HISTORIC AND DESIGN REVIEW COMMISSION

HDRC CASE NO: 2017-609
ADDRESS: 130 W WOODLAWN
LEGAL DESCRIPTION: NCB 1860 BLK 1 LOT N 100 FT OF 1 & 2
ZONING: R-4 H
CITY COUNCIL DIST.: 1
DISTRICT: Monte Vista Historic District
APPLICANT: Galvez Works LLC
OWNER: Andres Molina/Galvez Works LLC
TYPE OF WORK: Front porch modifications
APPLICATION RECEIVED: November 22, 2017
60-DAY REVIEW: January 21, 2018
REQUEST:

The applicant is requesting a Certificate of Appropriateness for approval to modify the existing front porch.

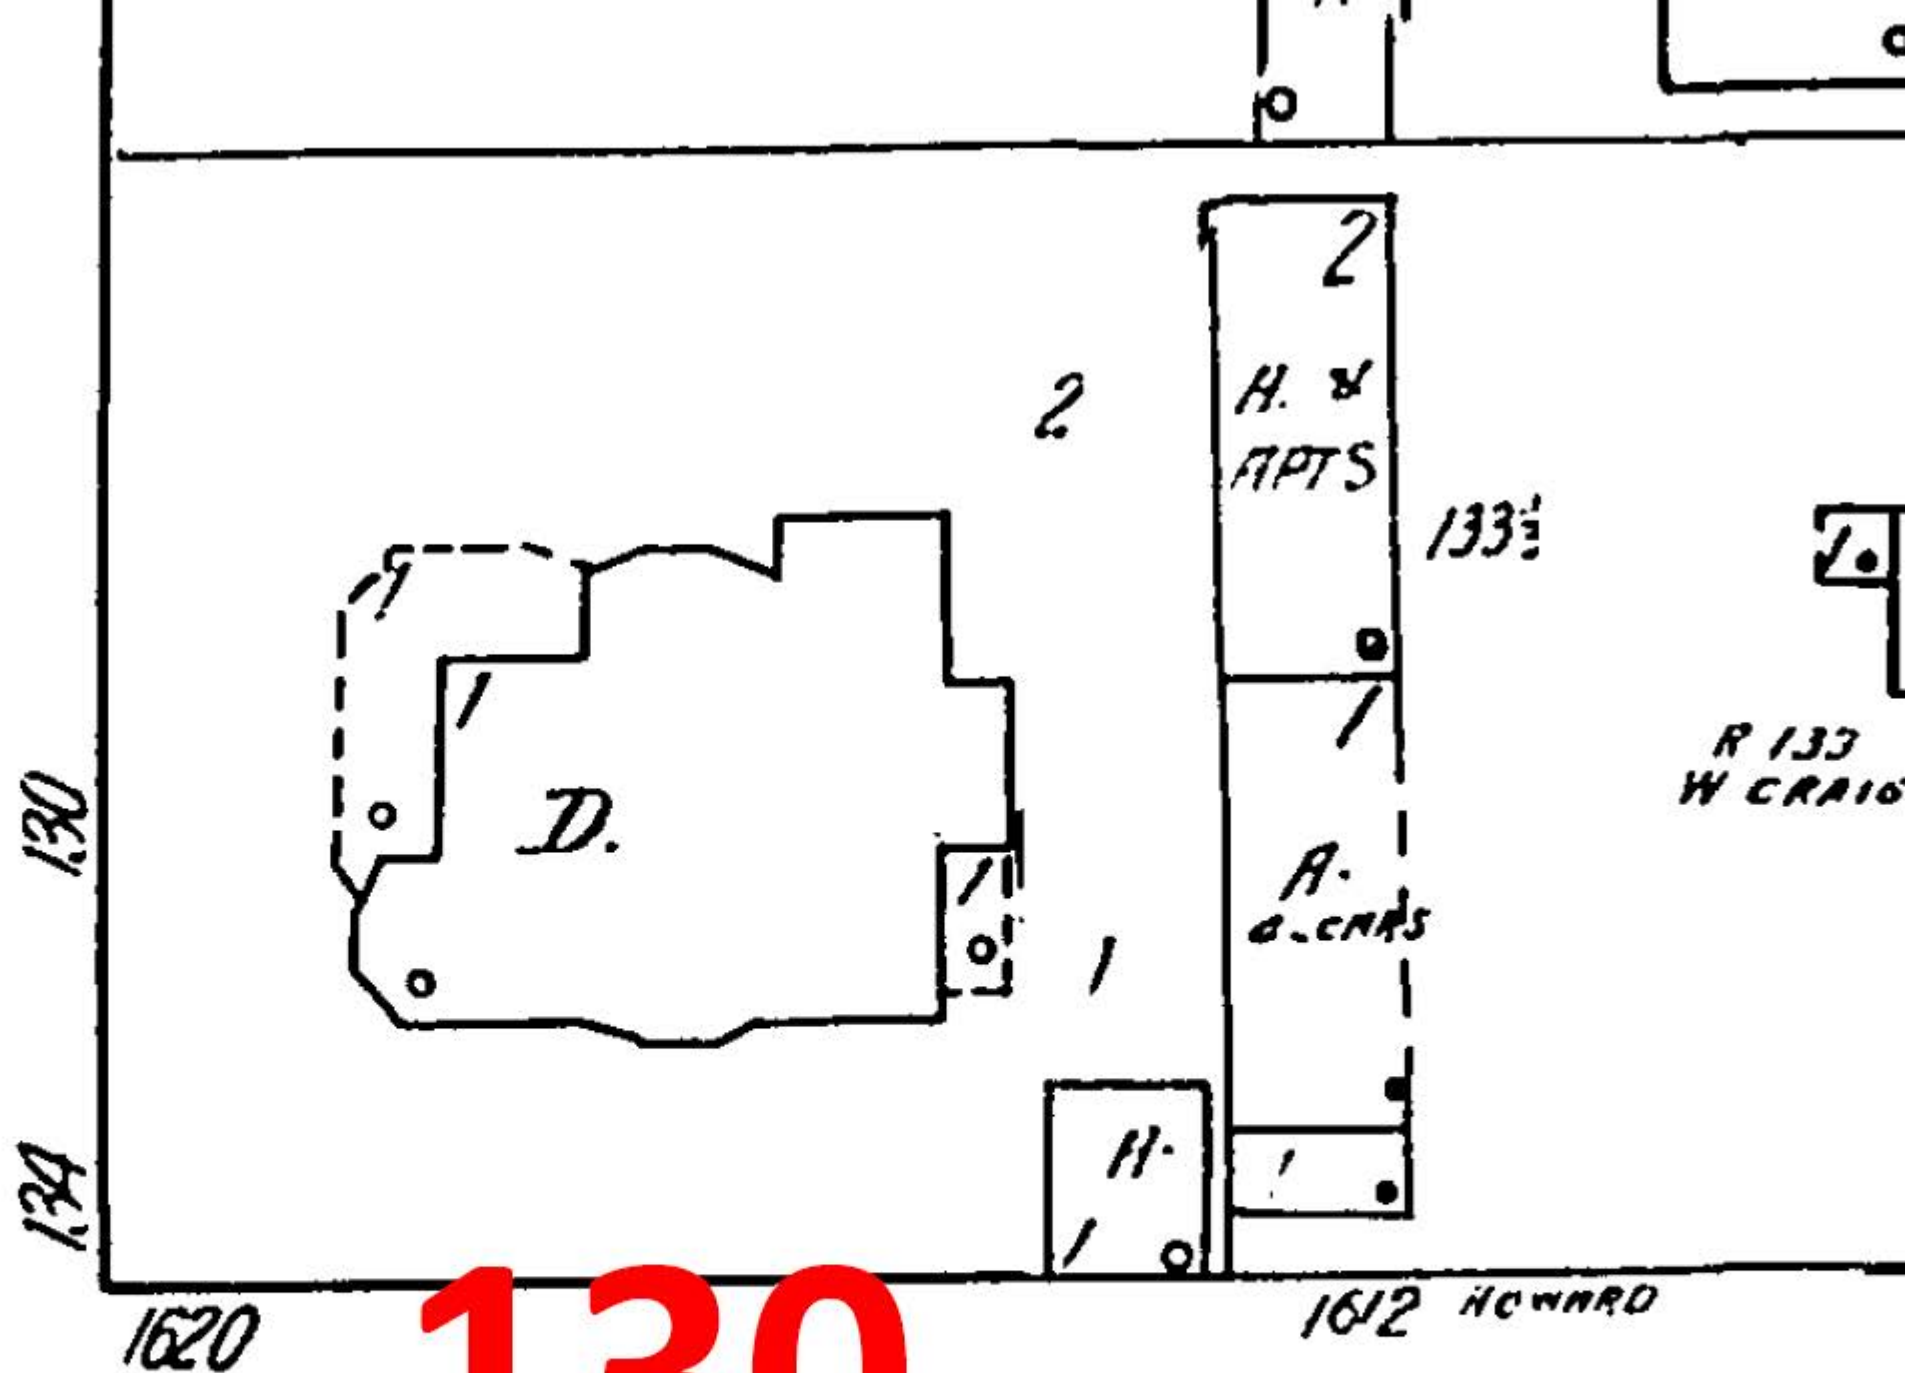
- b. The applicant is requesting approval to modify the existing front porch configuration. Based on Sanborn Maps and the typical porch configurations of Queen Anne homes of this construction period, the current configuration is not original. The 1911-1955 Sanborn Map indicates a metal roof with a separate front porch that wraps from the front bay window to the side bay on the west. This porch appears to have been removed, and the hipped roof was extended on the front façade to be flush with the front gable to cover the current porch entry. The existing roof is also shingle. The applicant has proposed to replace the existing porch roof with a new roof at a 3/12 pitch that extends the width of the porch base. The new roof will feature the same shingles as the existing structure. According to the Historic Design Guidelines, porches should be replaced in-kind when necessary. However, the existing condition is not original and incompatible with the style of the home. Any new porches should be based on the architectural style of the building and historic patterns. Staff does not find the replacement porch roof form consistent with the Guidelines as proposed.

FLOOR PLAN
ROOF PLAN

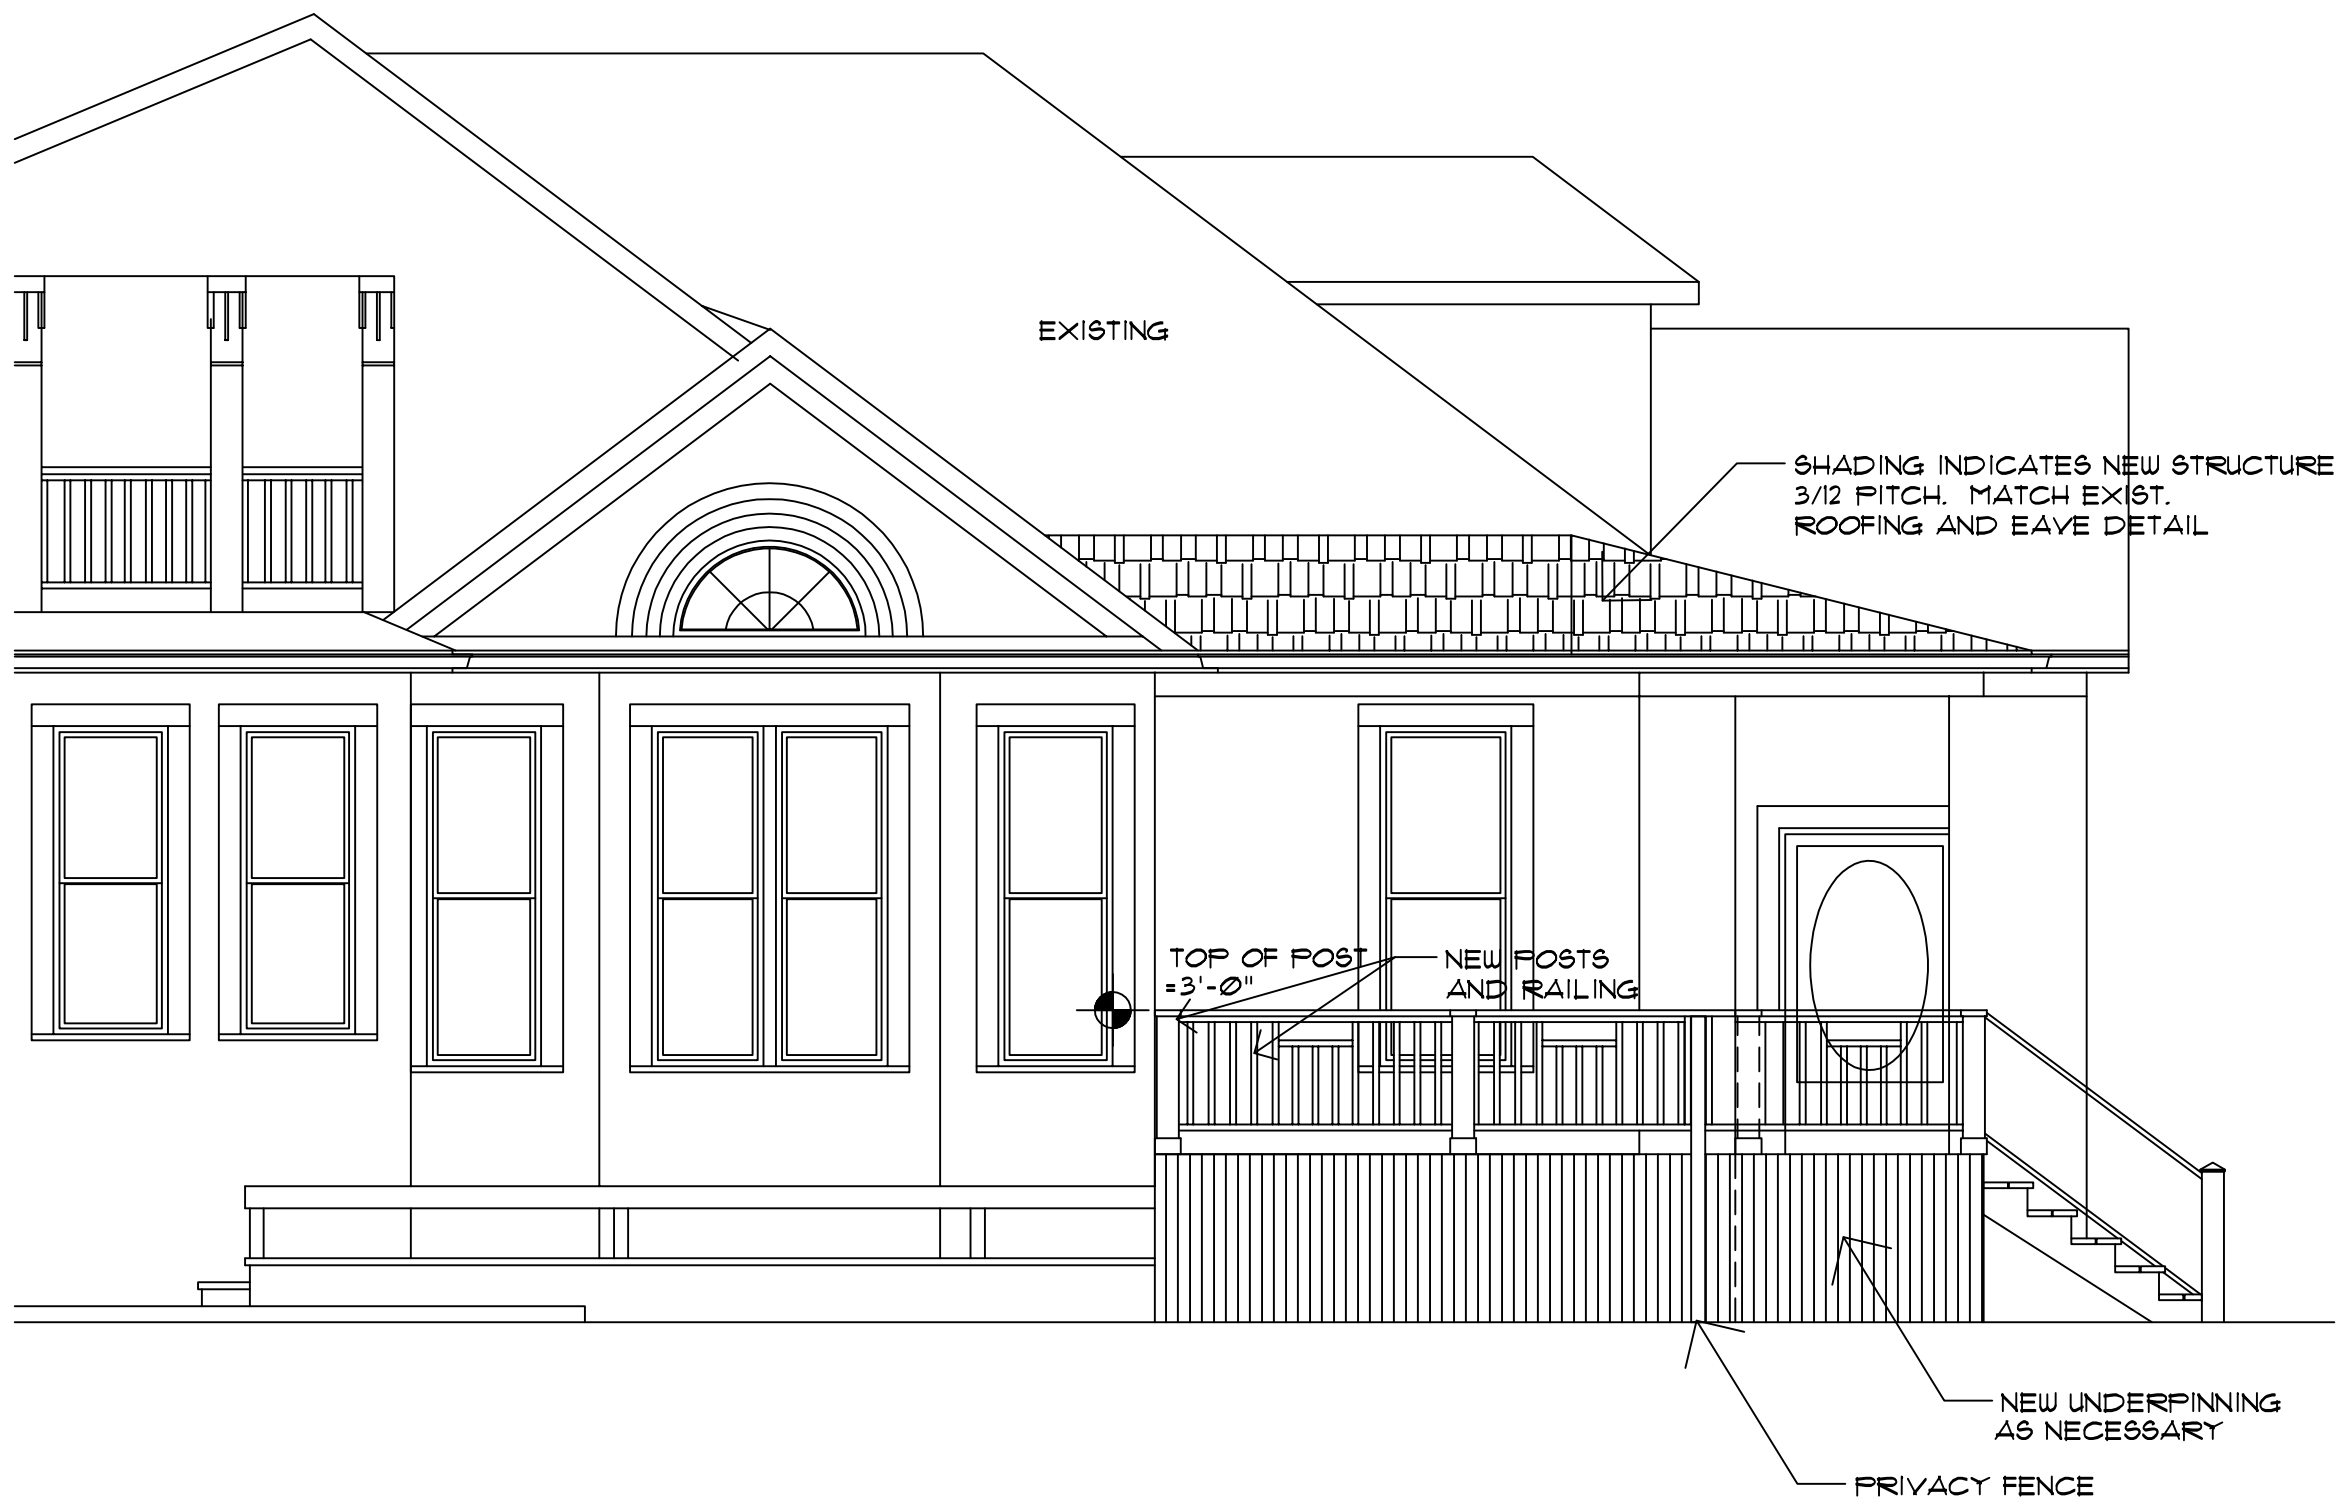
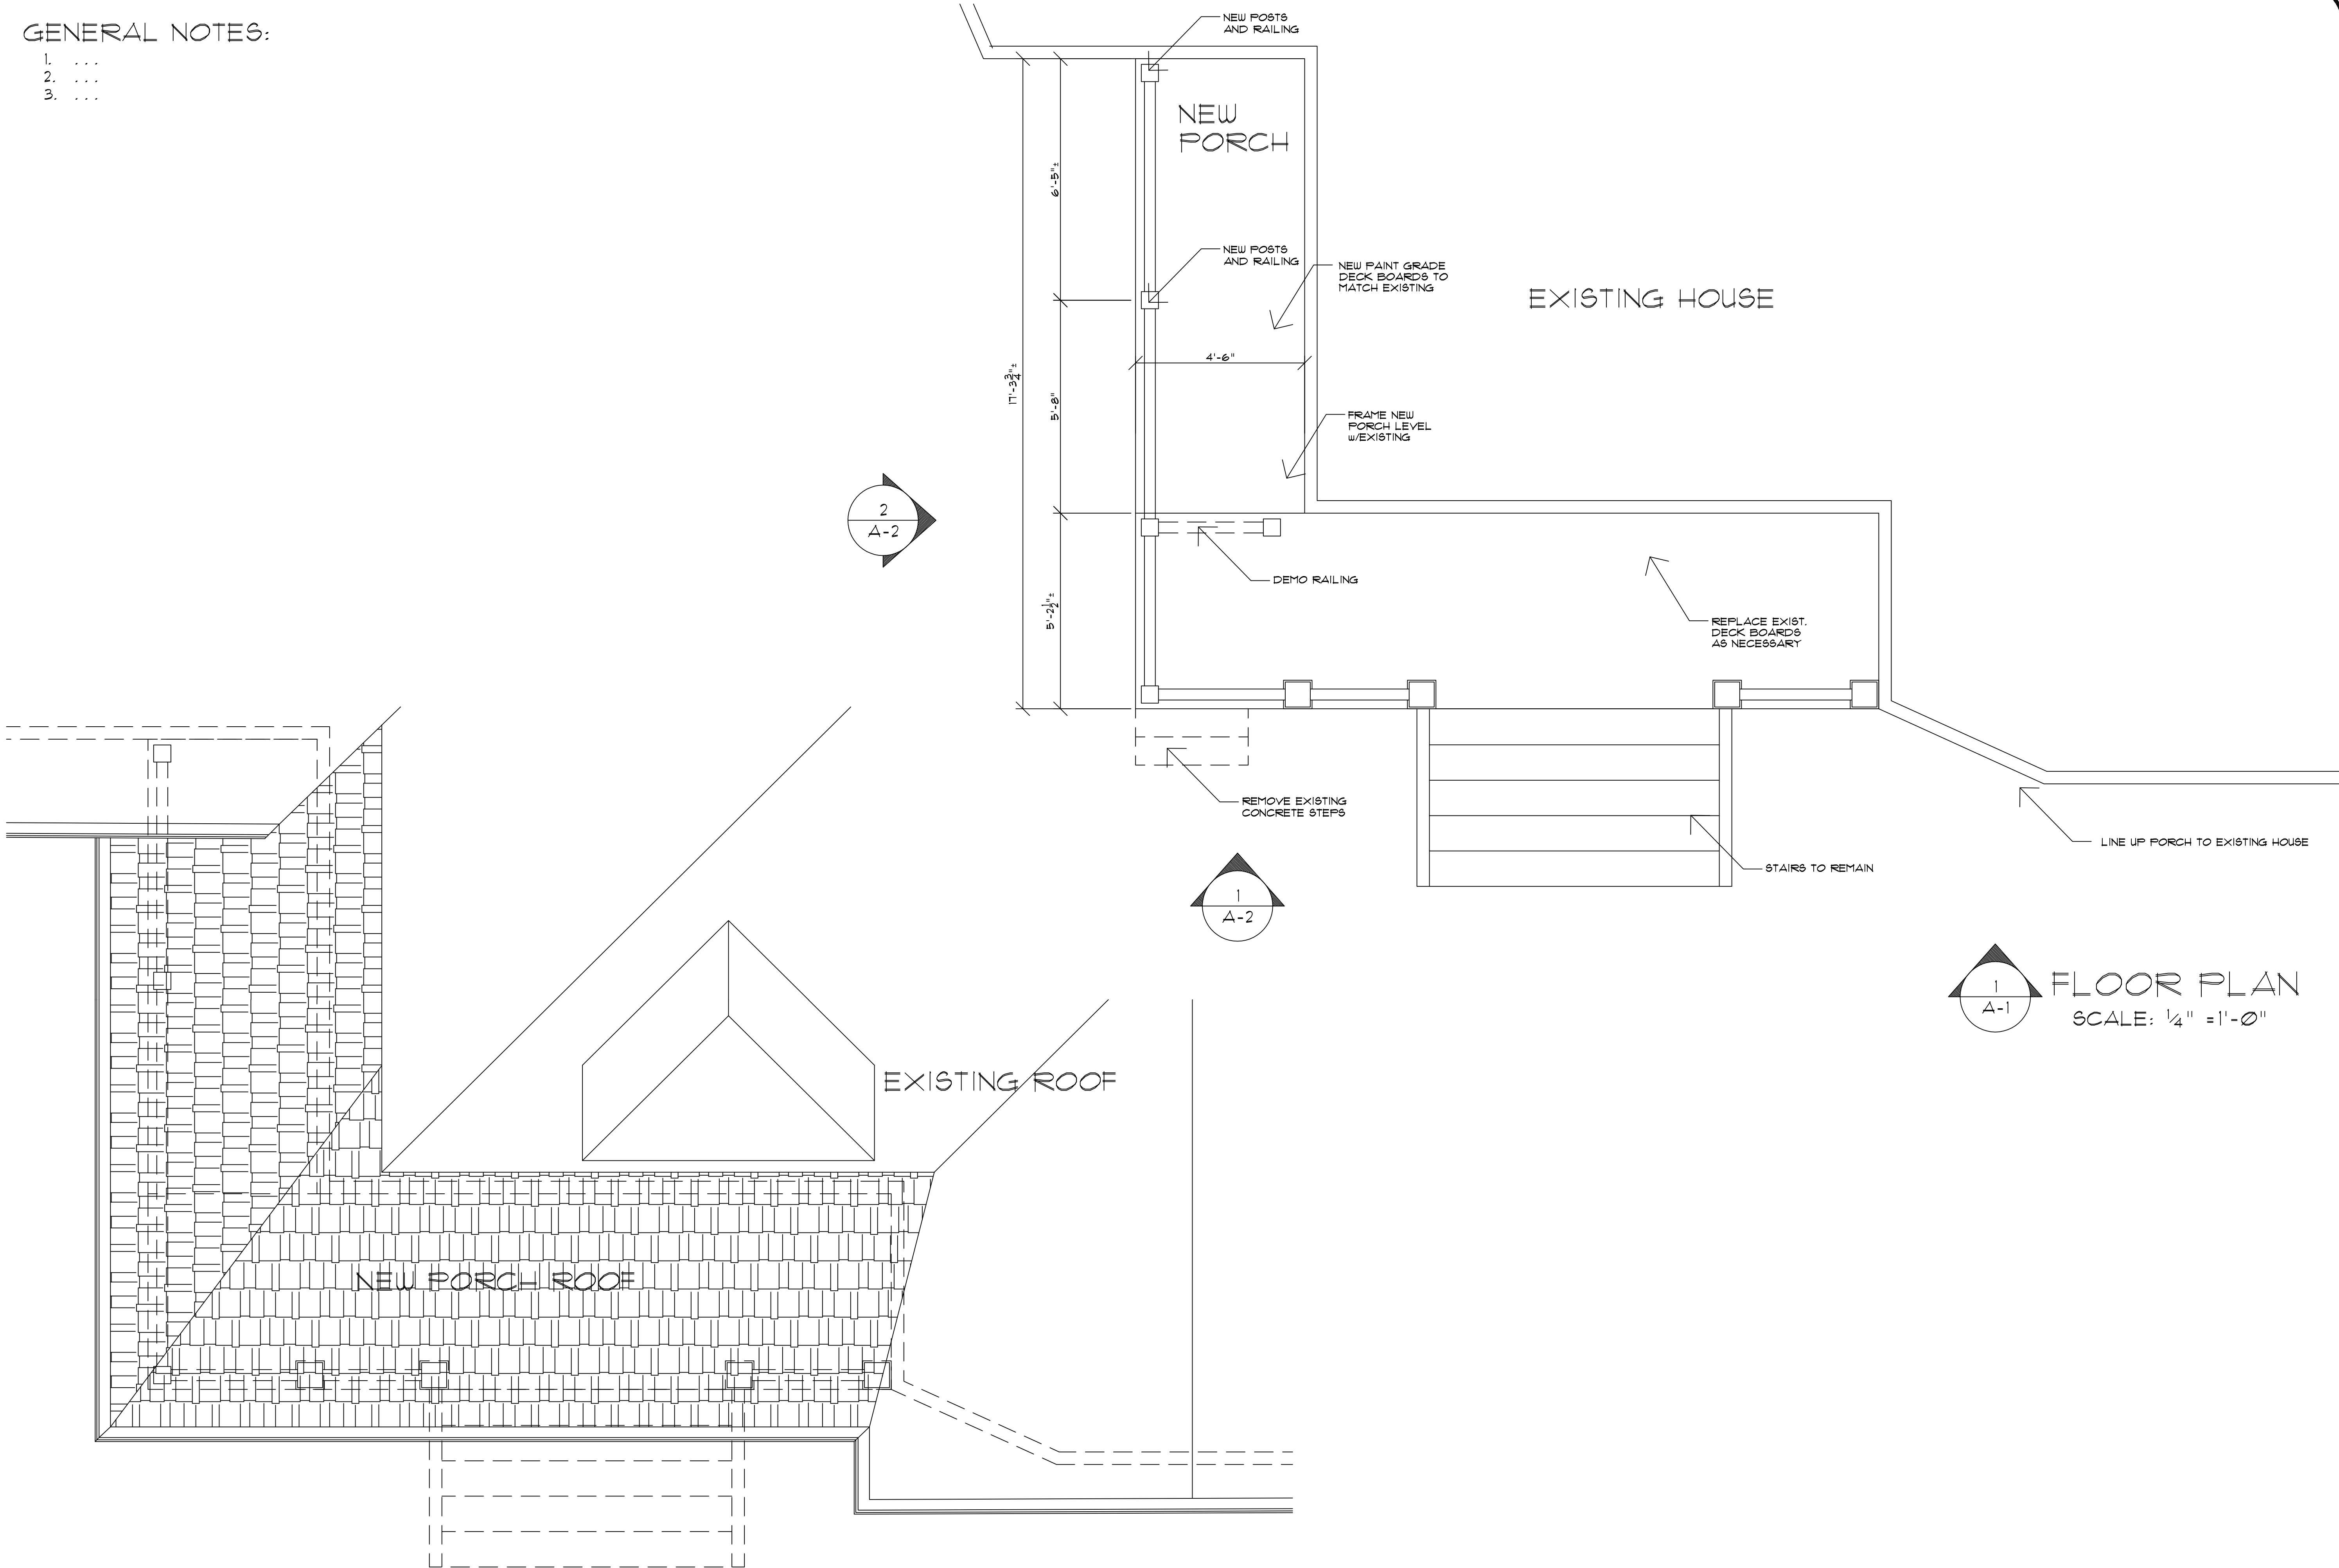
Staff does not recommend approval based on finding b. Staff recommends that the applicant proposes a front porch roofline that is more compatible with the style of the structure and is based on historical evidence as seen in the Sanborn Maps.
